Proposed F6 LSP – Schedule of Modifications			
No	Section	Modification	Justification
General			
1.	LSP Report throughout (e.g. Section 2.2.2.3, 2.2.2.4, 5.3)	Amend to include the relevant information as per the Mundijong District Structure Plan. Remove references throughout to the 'Mundijong-Whitby District Structure Plan 2011' and the 'Mundijong Precincts E1 & E2 Local Structure Plan'. Reference the approved Local and District Structure Plans throughout the LSP report.	The Mundijong-Whitby District Structure Plan 2011 is outdated. The Mundijong District Structure Plan 2020 is not a draft, it is approved by the WAPC. The Mundijong Precincts E1 & E2 Local Structure Plan has not yet been approved by the WAPC. Therefore, the locations of land uses within the Mundijong Precincts E1& E2 Local Structure Plan should not be used to inform the preparation of this Mundijong Precinct F6 LSP. The approved DSP and LSPs over this area should be referenced.

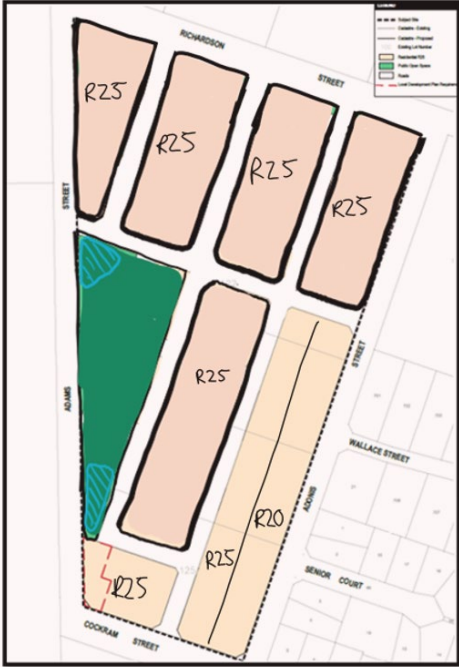
8.	Structure Plan Map, Report, and Appendices throughout	<p>Modify the Local Structure Plan map as follows, to the satisfaction of the Shire of Serpentine Jarrahdale:</p> <ul style="list-style-type: none"> • Reconfiguration of Public Open Space and drainage as per recommended modifications • Removal of Local Development Plan identifications • Modification of densities as per recommended, demonstrating a base density of R25, with R20 densities for lots fronting Adonis Street. 	<p>As per recommended modification 4 regarding residential densities.</p> <p>Local Development Plan boundaries are to be lot-specific, determined at the subdivision stage.</p> <p>The proposed configuration of POS provides limited usability for residents and is recommended to be modified. The POS areas proposed are small, triangular portions of land located mainly along Adams Street. These spaces appear impractical and lack usability for active recreation. Whilst it may be reasonable to have some element of POS which is constrained in function due to drainage, officers consider that the current design provides for a lack of uses and activities. On lots which have limited private open space available, distributing POS in a manner which results in limited functionality is not supported, and impacts the liveability of this future neighbourhood. It is recommended</p>

Proposed F6 LSP – Schedule of Modifications			
No	Section	Modification	Justification
			that the LSP map be redesigned to ensure a well-distributed parkland which provides for a range of uses and activities.

27.	Local Structure Plan Map	<p>Reconfigure the Public Open Space in consultation with the Shire of Serpentine Jarrahdale, to improve the functionality and the usability for active recreation of Public Open Space, as suggested in the below image subject to detailed design.</p> 	<p>The proposed configuration of POS provides limited usability for residents and is recommended to be modified. The POS areas proposed are small, triangular portions of land located mainly along Adams Street. These spaces appear impractical and lack usability for active recreation. Whilst it may be reasonable to have some element of POS which is constrained in function due to drainage, officers consider that the current design provides for a lack of uses and activities. On lots which have limited private open space available, distributing POS in a manner which results in limited functionality is not supported, and impacts the liveability of this future neighbourhood. It is recommended that the LSP map be redesigned to ensure a well-distributed parkland which provides for a range of uses and activities</p>
